HYAC REPLACEMENT
STATE POLICE TROOP L
HEADQUARTERS

SHEET TITLE:
MECHANICAL WATER PIPING PLAN

M103

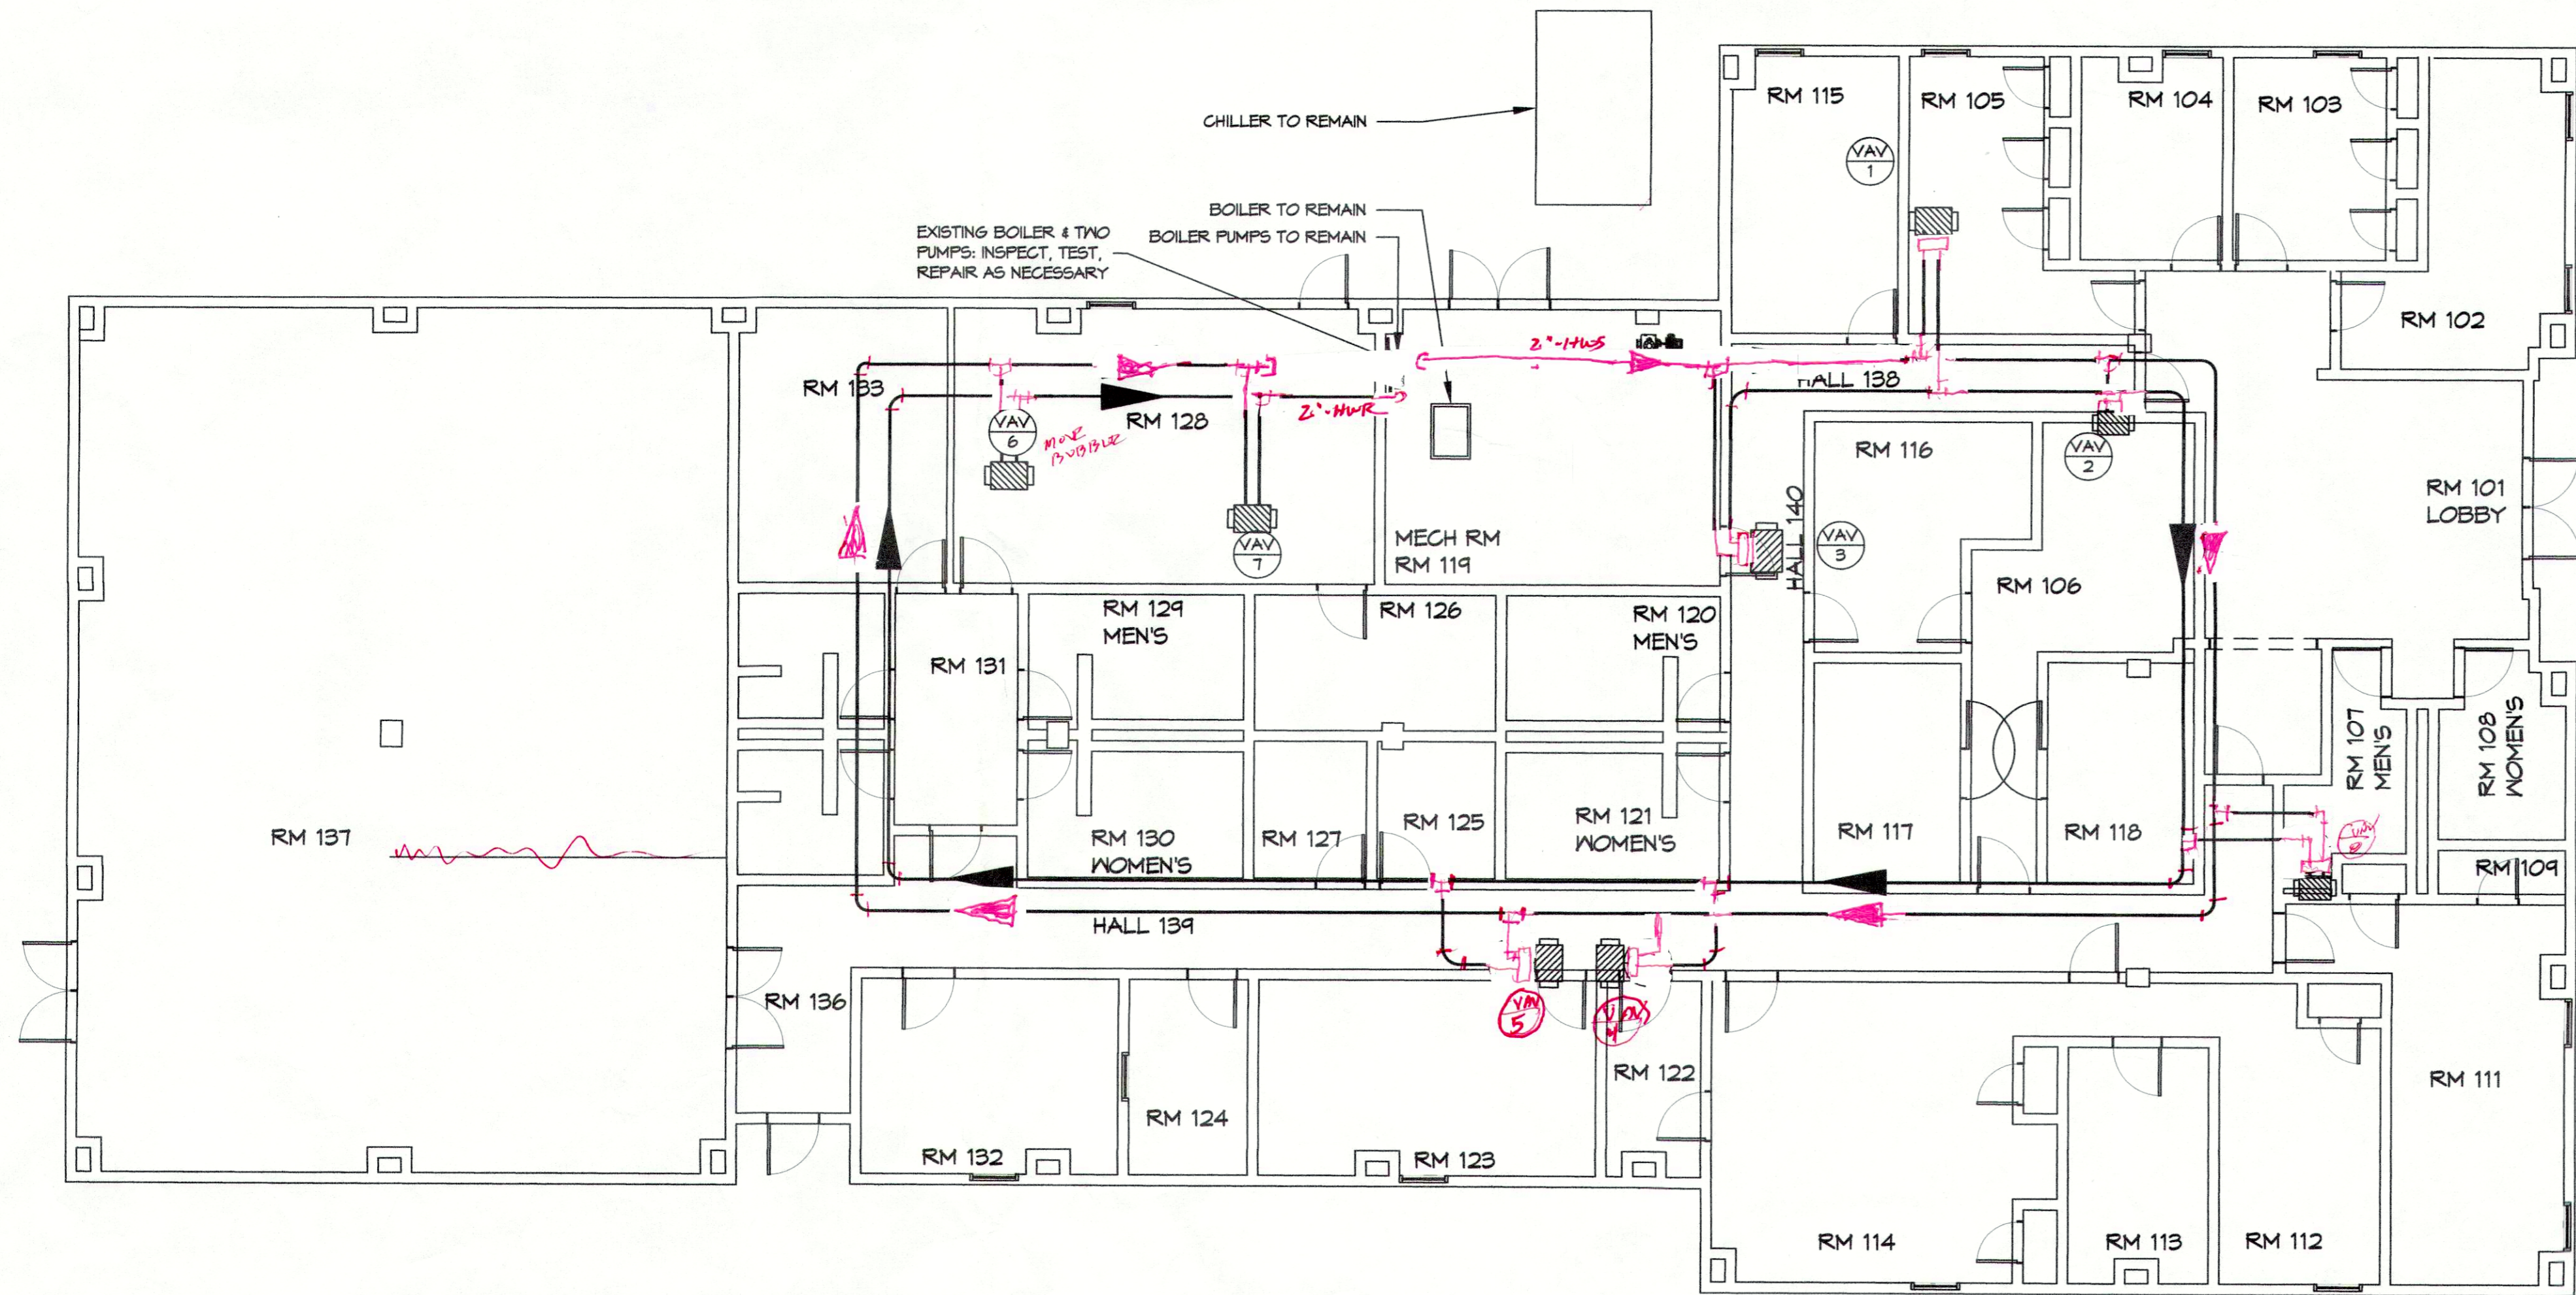
*- BOILER PERFORMANCE?
- CHILLED WATER PUMP DATA?
- SIZE OF O/A LOUVER?*
